Amendment Notice 2

Licence Number L4504/1981/17

Licence Holder South32 Worsley Alumina Pty Ltd

Premises Worsley Alumina Refinery
Gestaldo Road
COLLIE WA 6225
Lease No 3116/7574

Figure 1: General arrangement of process water inputs and the outlet of WB1
(source Figure 23 from Design Report – Water Body 1, AECOM, 2017a)

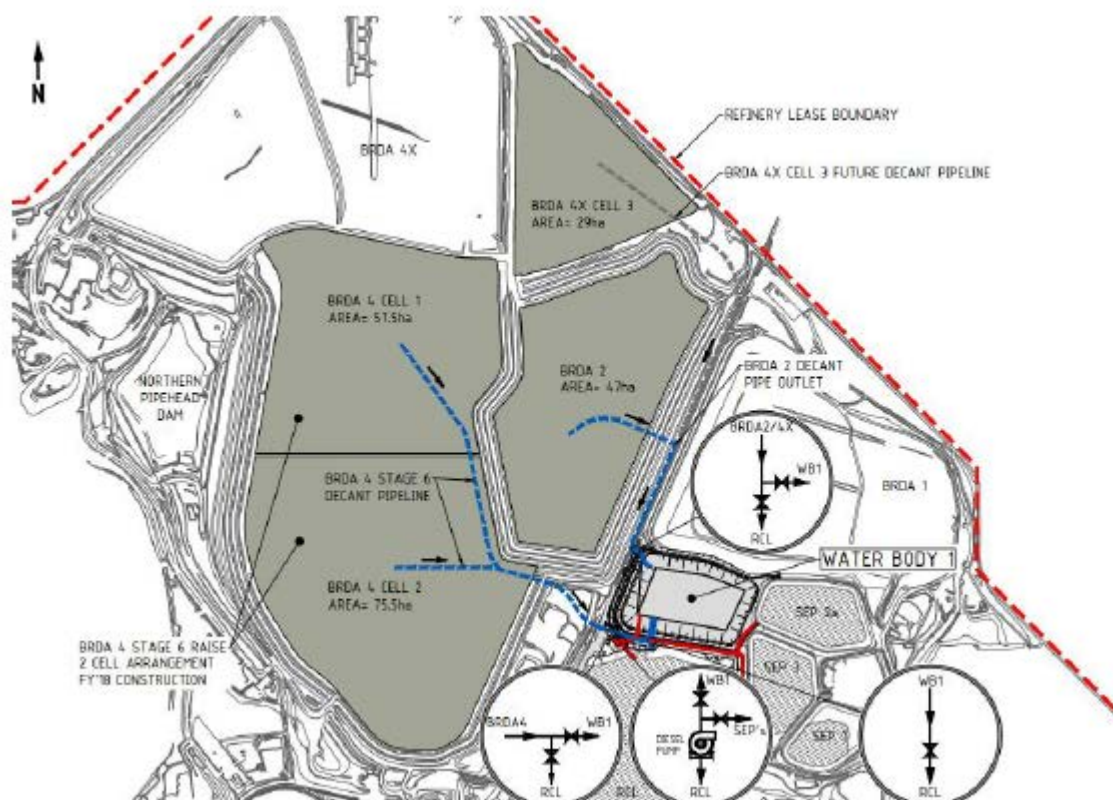
South32 seeks approval to construct and operate an additional process water storage dam. The proposed works involve converting an existing excavated area adjacent to the Refinery Catchment Lake (RCL) into a process water holding dam.

The dam (identified as Water Body 1) (WB1) has been designed to incorporate an in-situ compacted base, a geosynthetic liner and an under drainage system. It is proposed to be used as a balancing pond for return liquor from the Bauxite Residue Disposal Areas (BRDAs) and also for the storage of process water providing about 1.1GL of additional storage capacity. The proposed infrastructure is set out in Appendix 2 and illustrated in Figures 1 and 2 below.

Figure 3: Location of Water Body 1 in relation to the Brunswick and Collie Rivers

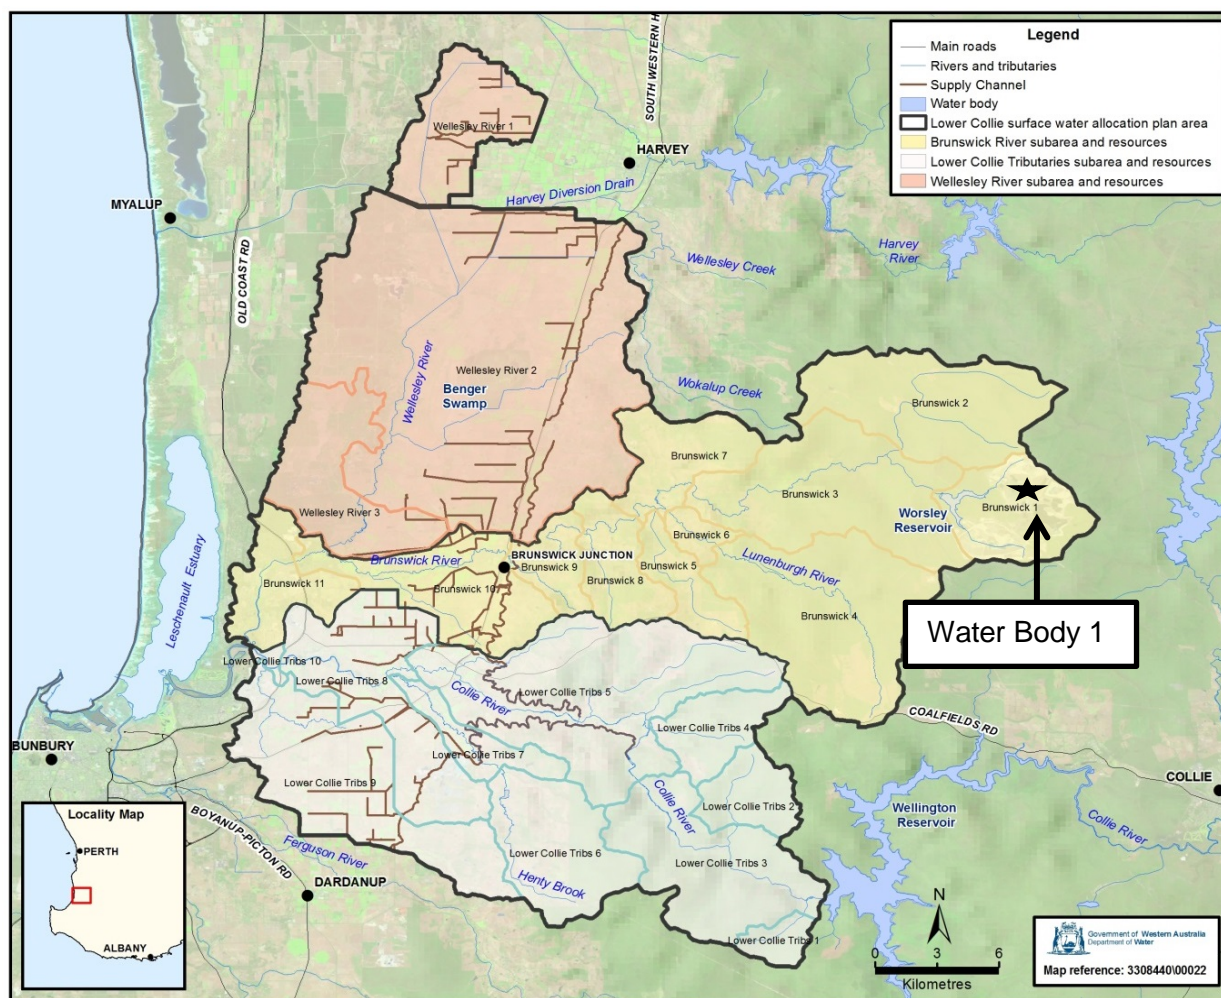
The location proposed for WB1 is shown in Figure 2 within the Refinery and Figure 3 within the local area. The Refinery is approximately 15km northwest of Collie on the Darling Plateau within the Augustus (minor) and Brunswick (major) river catchments.

- (a) at the location shown in Figure 2; and
- (b) prior to 30 June 2020.
